an application for approvals by  
Matakanui Gold Limited to establish,  
operate, rehabilitate and ultimately  
close an open pit and underground gold  
mining operation known as the Bendigo-  
Ophir Gold Project

**Statement of Evidence of  
Eric Torvelainen on behalf of  
Matakanui Gold Limited in response to  
Section 53 Feedback  
Engineered Landforms**

Dated: 17 April 2026

**MATAKANUI GOLD LIMITED  
BENDIGO-OPHIR GOLD PROJECT - FAST TRACK APPROVALS ACT  
RESPONSE TO SECTION 53 COMMENTS  
STREAM AND SURFACE WATER DIVERSIONS LETTER**

**BENDIGO-OPHIR GOLD PROJECT  
SHEPHERDS CREEK & RISE & SHINE AREA  
SURFACE WATER AND STREAM DIVERSIONS  
OPERATIONAL STAGE - SITE PLAN**

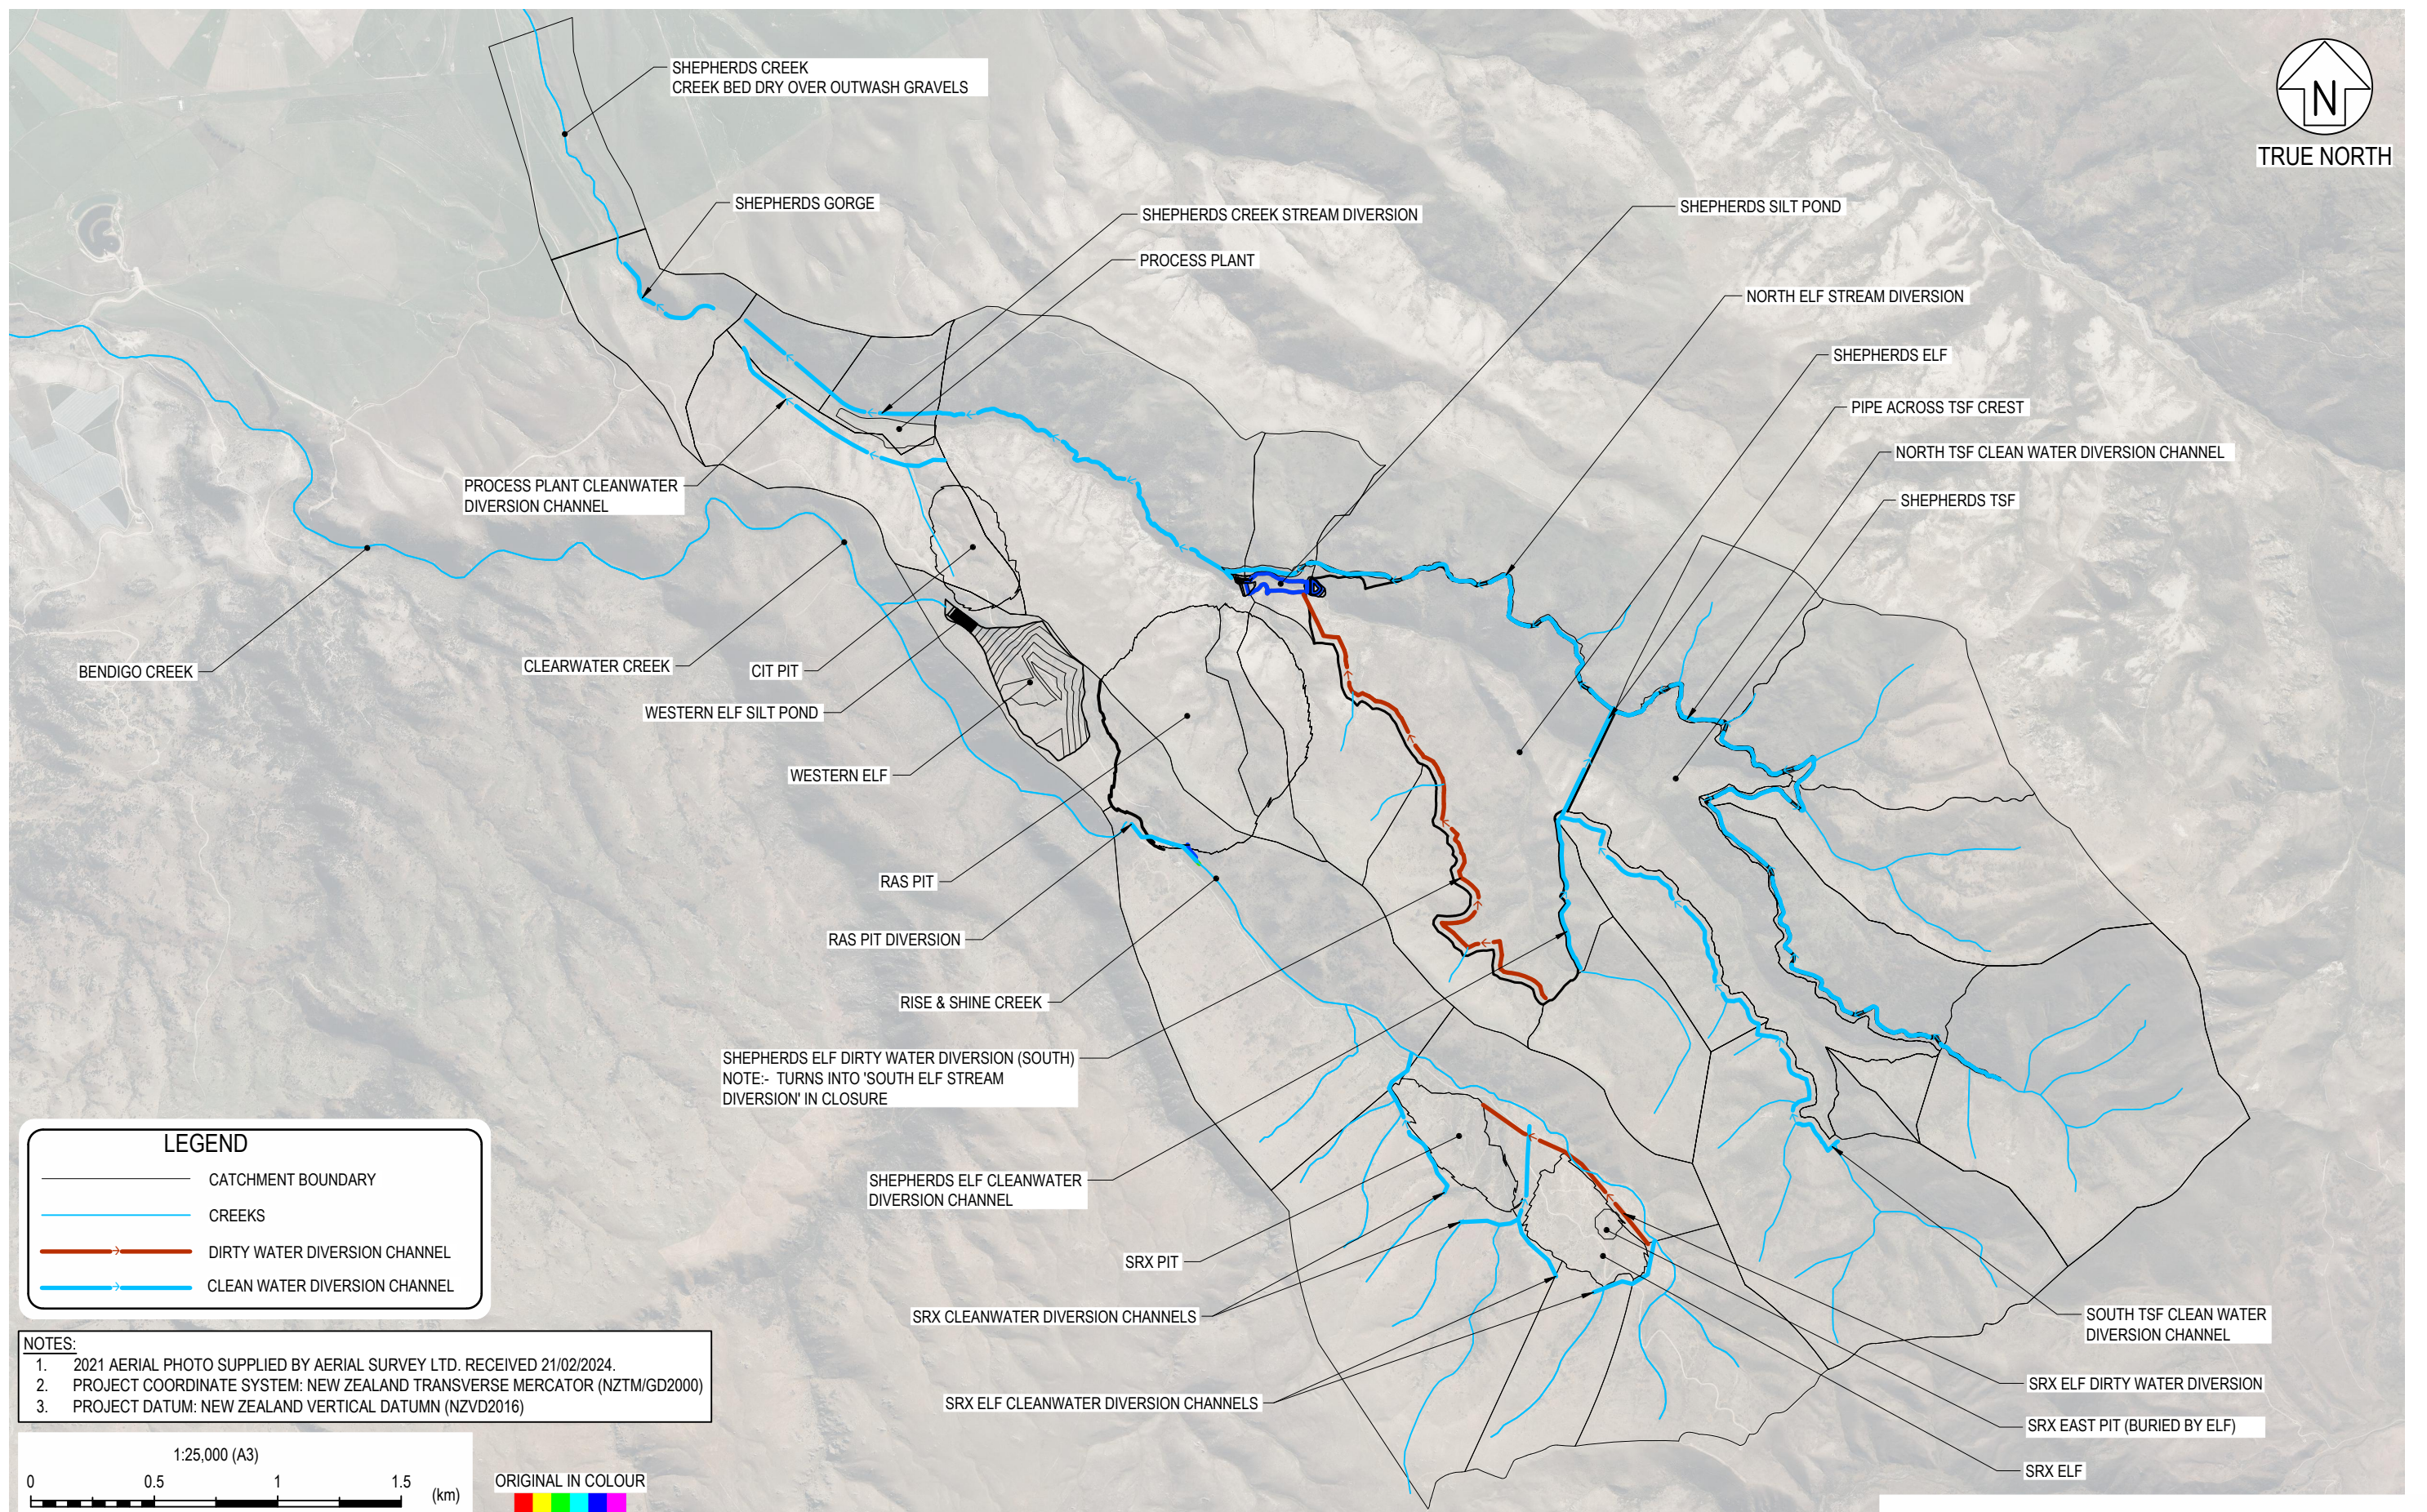
***Paragraph 163(a) – “For every proposed diversion channel in Shepherds Creek catchment or Rise and Shine Creek catchment (except the Rise and Shine Diversion Channel discussed in Report B.24) that will be onsite for two years or more:***

***ii. engineering drawings***

- (a) SRX ELF Clean Water Diversion Channels (**SRX ELF CWDC**);
  - (b) SRX Clean Water Diversion Channels (**SRX CWDC**);
  - (c) SRX ELF Dirty Water Diversion Channel (**SRX ELF DWDC**); and
  - (d) Rise and Shine Stream Diversion (**RAS SD**).
8. These are also shown the figure in Part C of the Substantiative Application under Project Map C.36, apart from SRX ELF DWDC. In response to the comment an additional technical letter outlining the proposed details for these channels mentioned above is included as **Attachment 1** to this statement of evidence. The SRX ELF DWDC is shown on Figure 2 in Attachment 1.

7. I list the diversion channels that will be onsite for more than two years.

and Bendigo Aquifers. The proposed site layout and locations of diversions are shown on the attached Figure 02 for the site operational stage and Figure 03 for site closure.

FIGURE 06

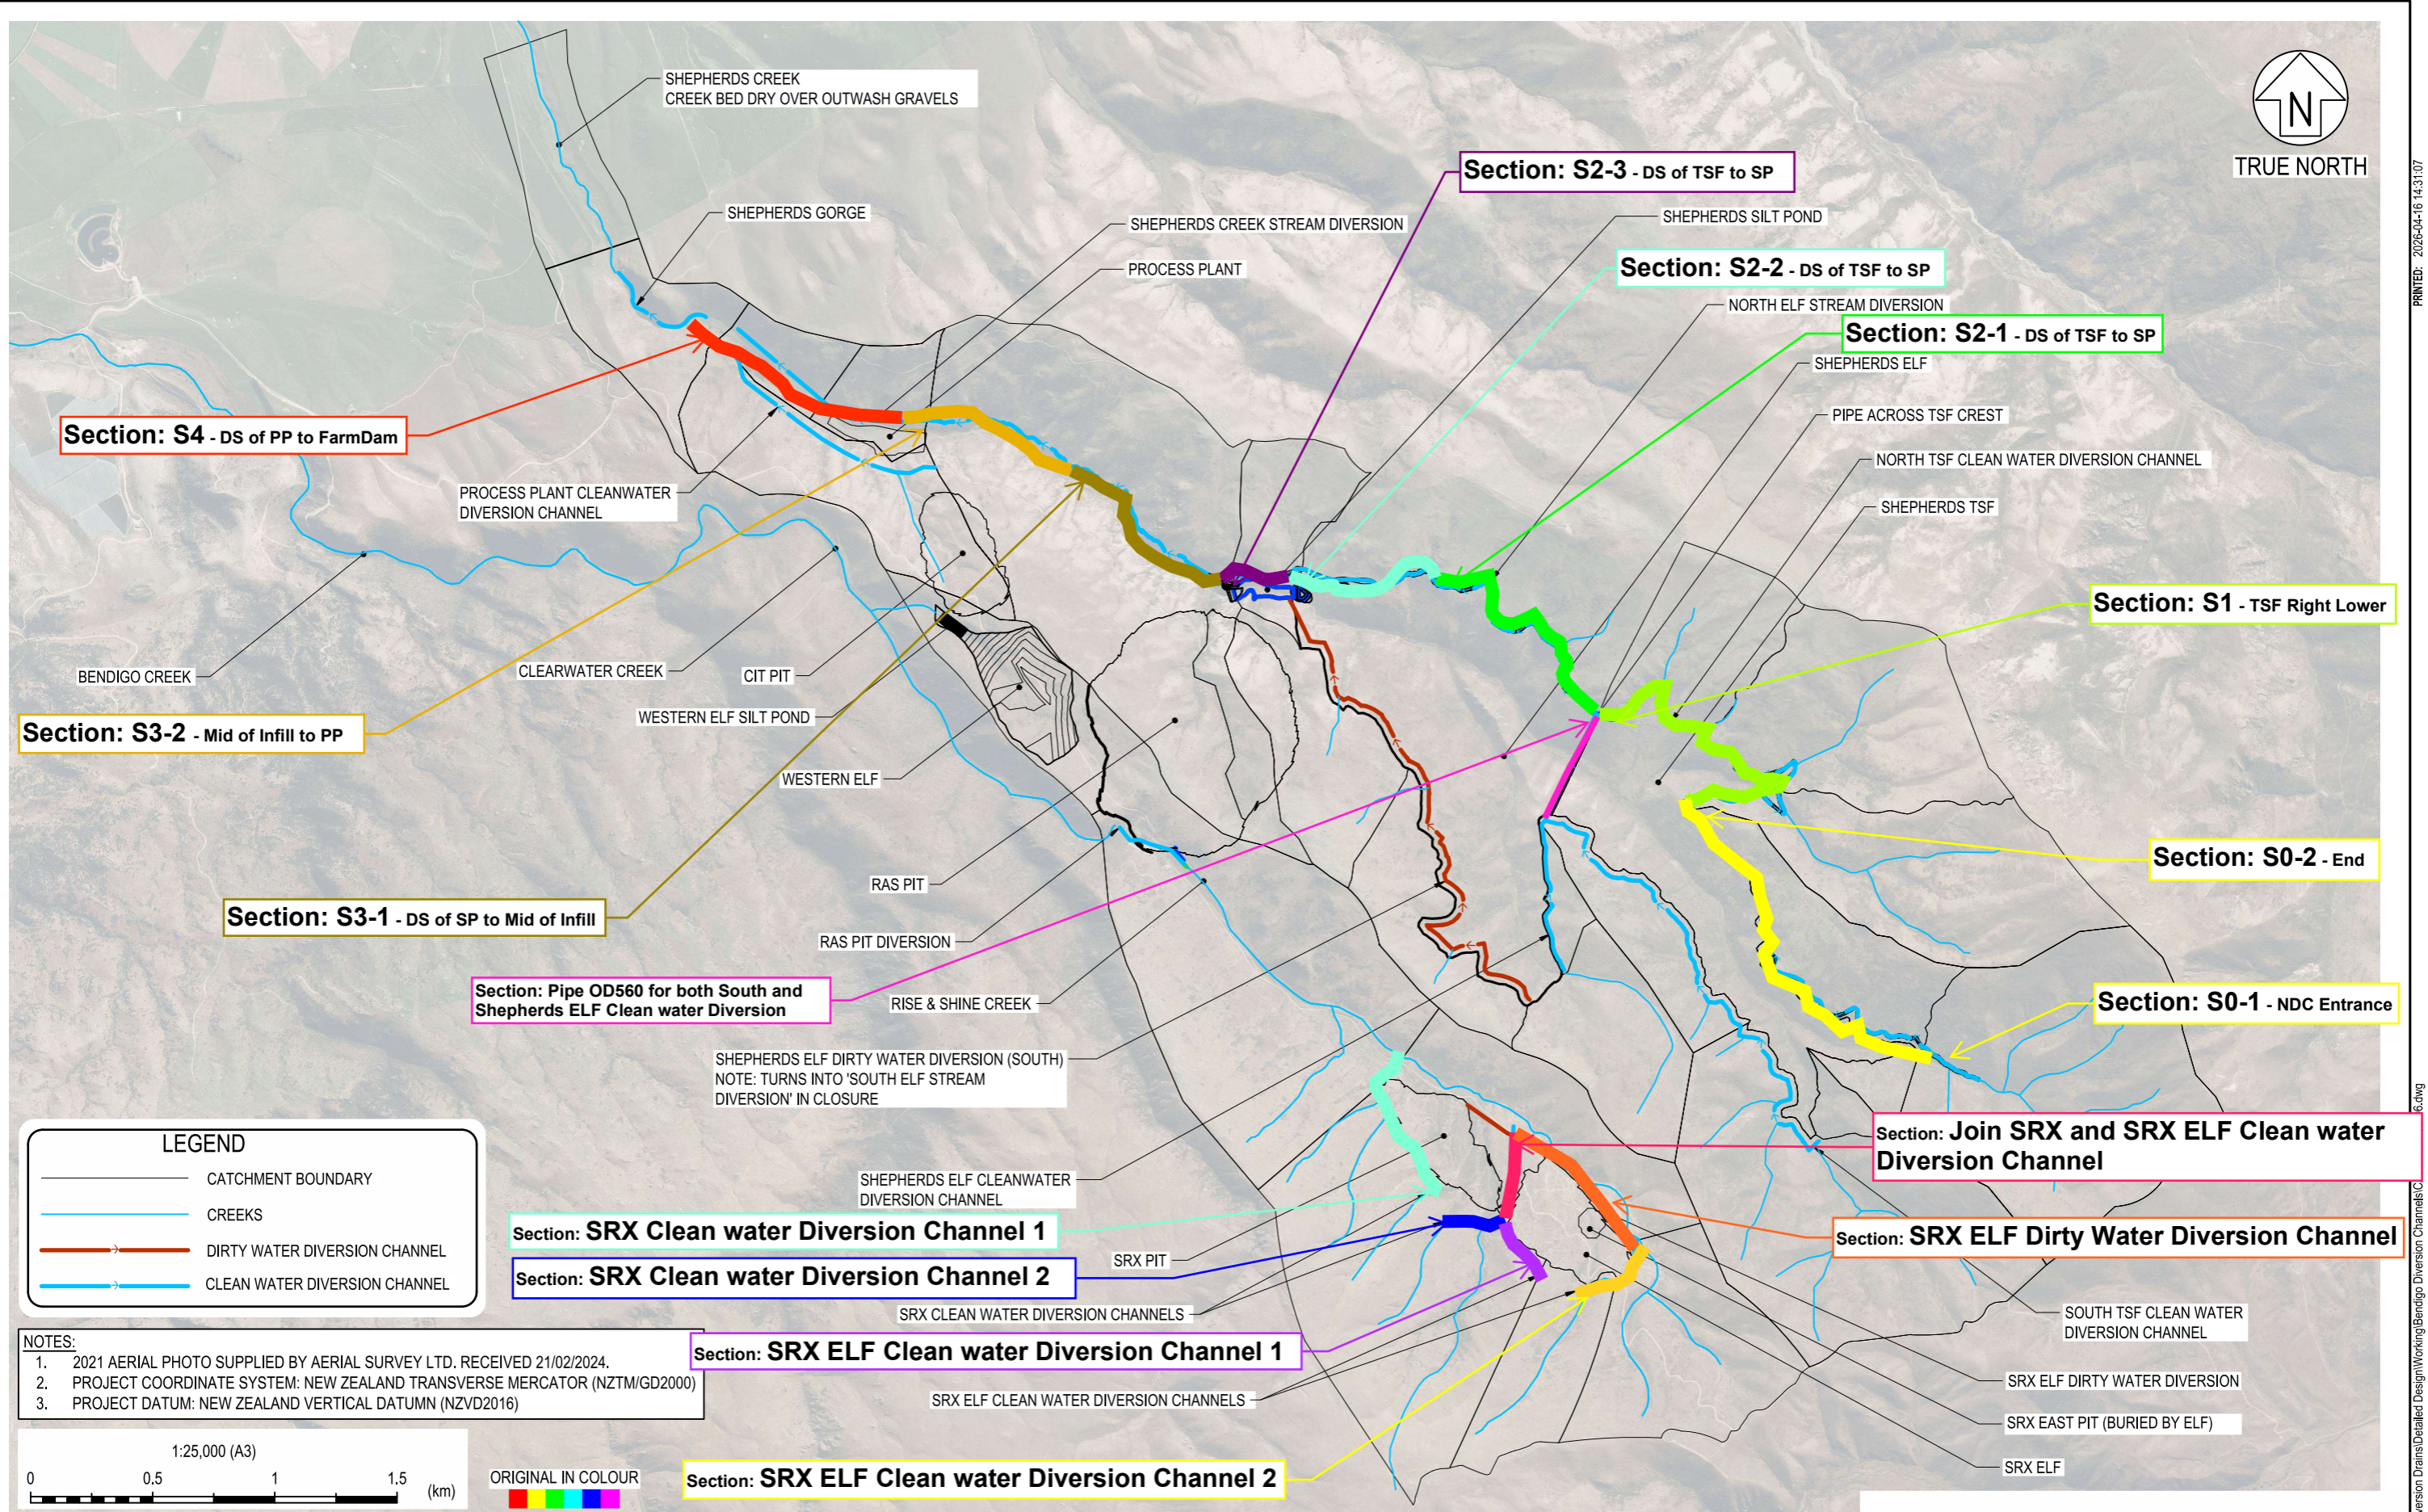
***vi. hydraulics / flood design calculations to support channel sizing”***

Design flows have been assessed at various locations for the purpose of diversion channel sizing. Section locations were selected to account of varying gradients and catchment sizes. A summary of the design section locations is presented in Figure 06.
